AGENDA

President and Board of Trustees
Village of Arlington Heights
Board Room

November 20, 2017

File Number: PC# 17-010
Project Title: St. Edna's Catholic Church
Address: 2525 N. Arlington Heights Rd.
PIN: 03-17-101-019

NO.	DESCRIPTION	DATE
MECHANICAL DETAILS & SPECIFICATIONS		
DRAWING: AT, BC, KM		PLOT DATE: 05/01/2017
CHECKED: STT	M3.2	
JOB NUMBER: M16025

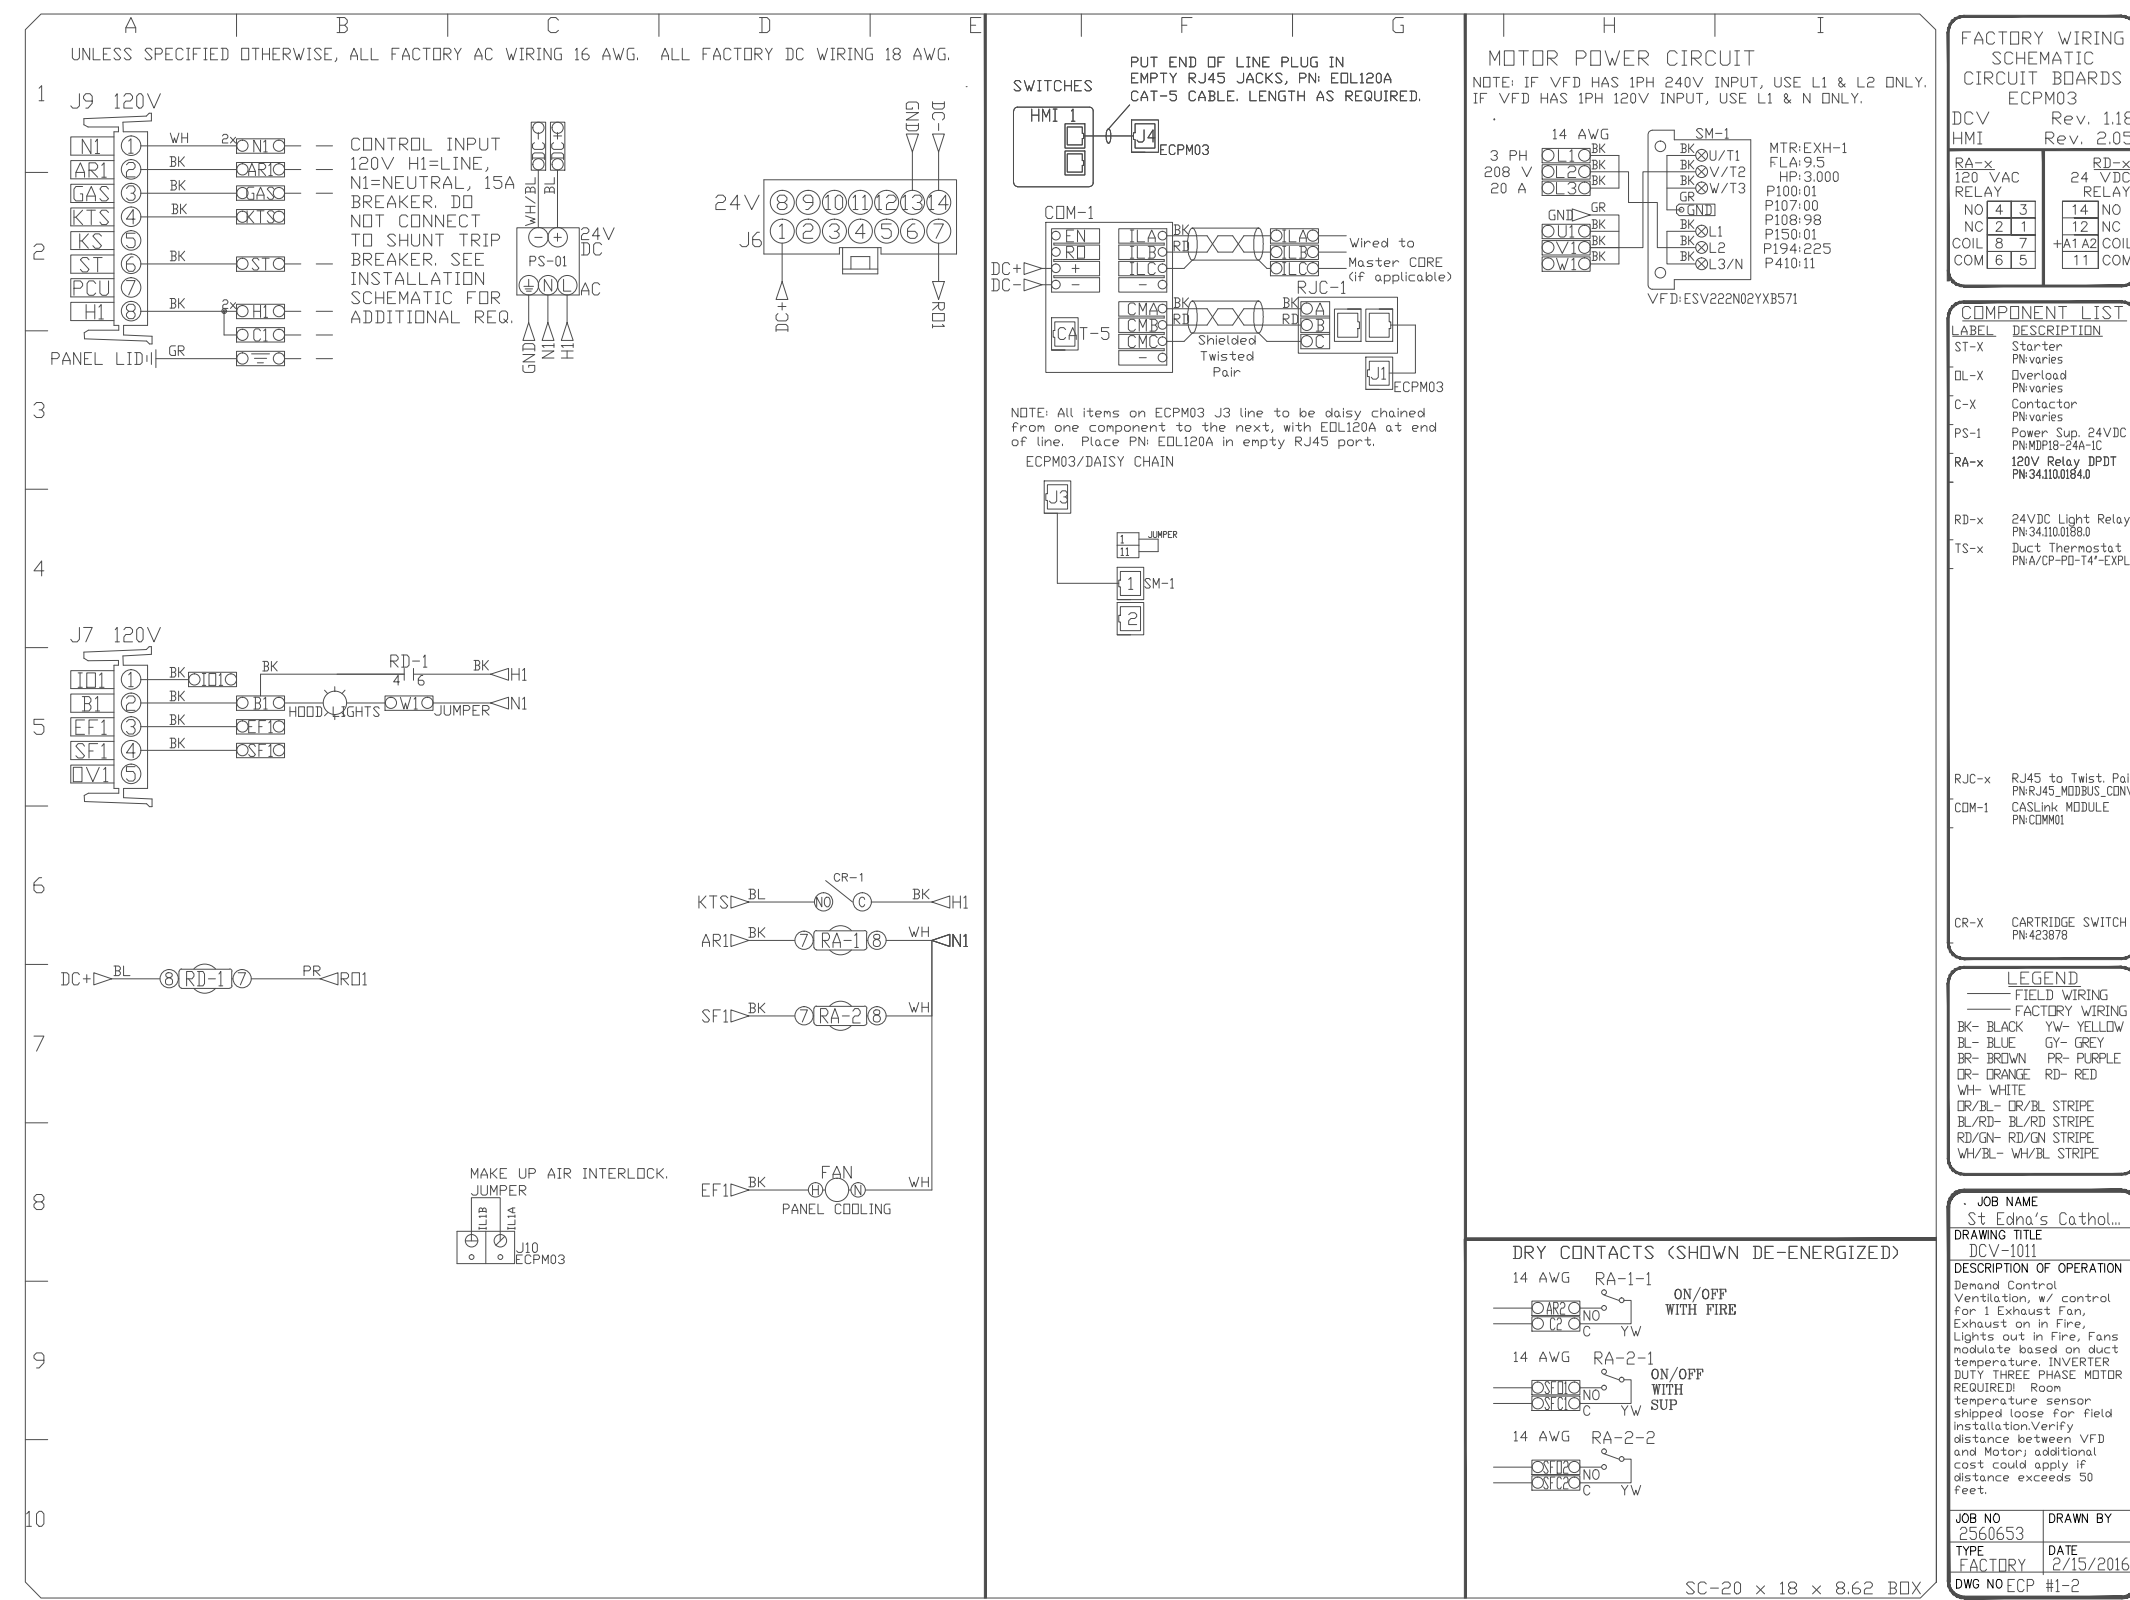
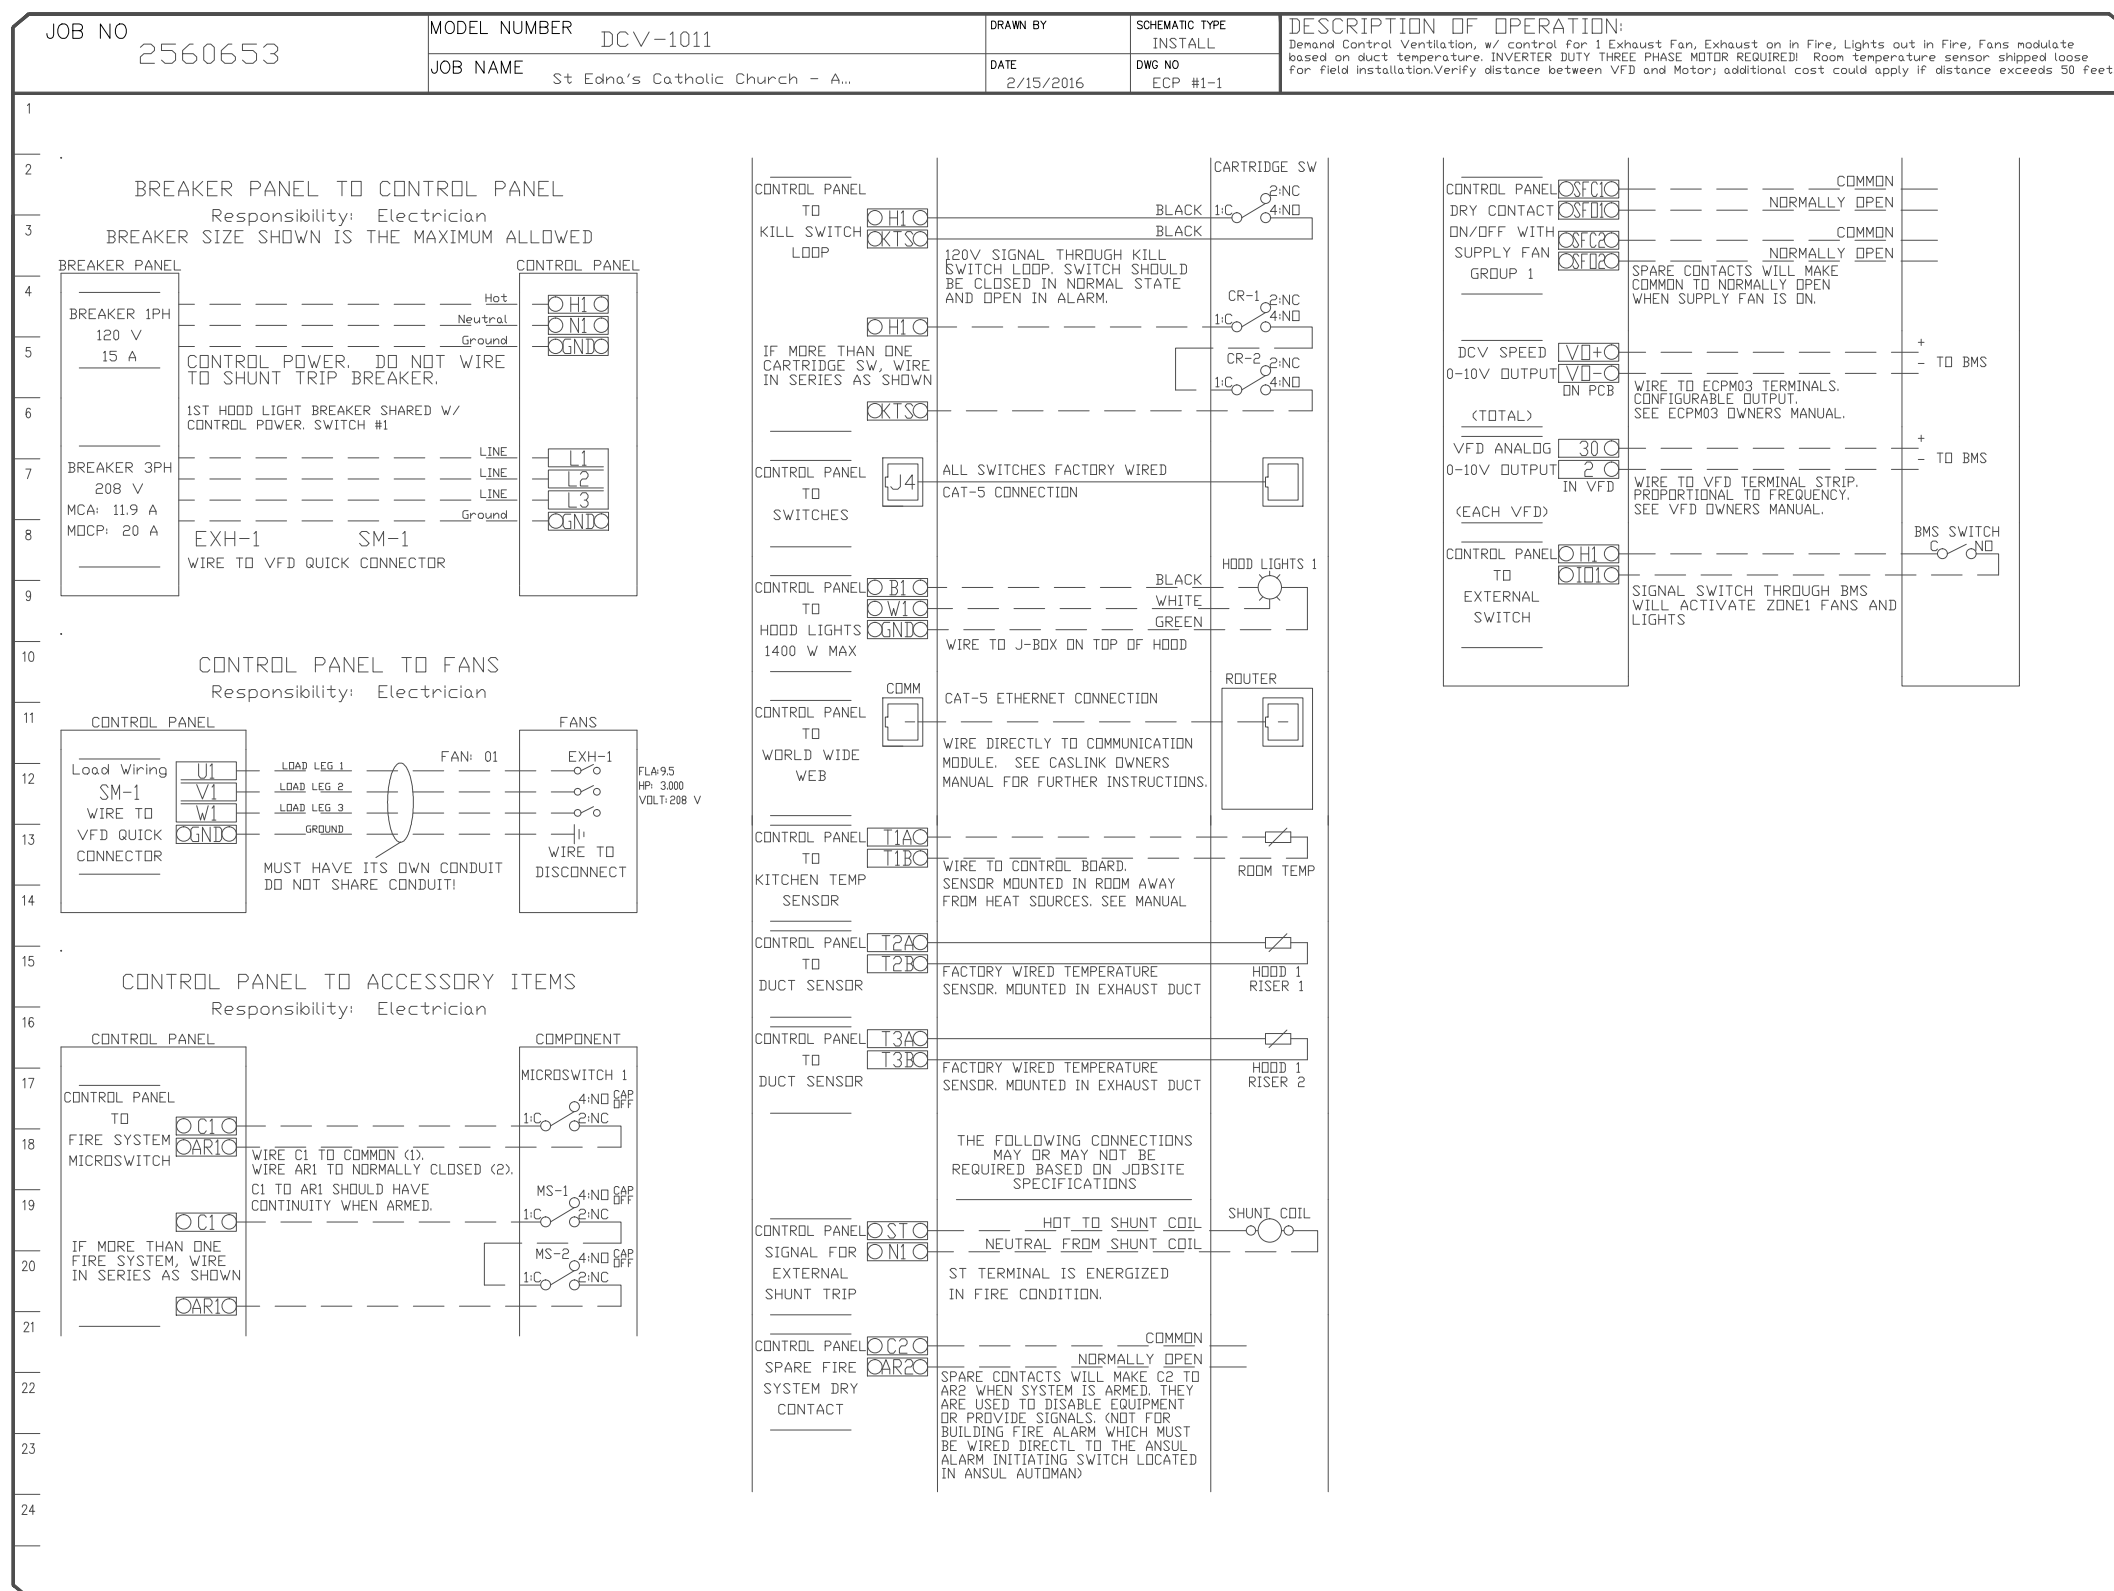
4. If the proposed kitchen will have cooking facilities a Hood and Duct fire suppression system may also be required.
A type 1 hood with a fire suppression system has been provided. See sheets M3.1 and M3.2 included as part of this response.
